S E R V I C E N O T E

J2523B Internet Advisor

Serial Numbers: US35300104 and US35300105

Possible fire hazard

Note Drawing shown with the rear panel removed.

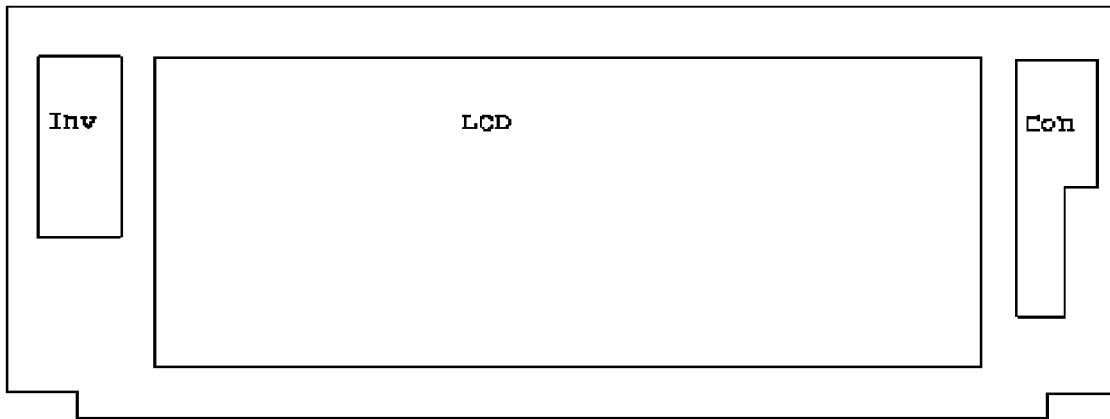
The 0950-2937 Display Board Inverter Assembly installed into the J2523B display does not meet Agilent's Fire Retardant standards and should be replaced. Inverter boards 0950-2937 marked with LOT 56 on the transformer in instruments with the serial number listed should have this modification to prevent instrument damage.

1. Remove the back panel from the display by removing 6 painted screws.
2. Locate 0950-2937 (note drawing marker “Inv”), remove 2 screws and cables from the board and remove the inverter board from the display assembly.
3. Replace the board with 0950-2937 with different LOT number.
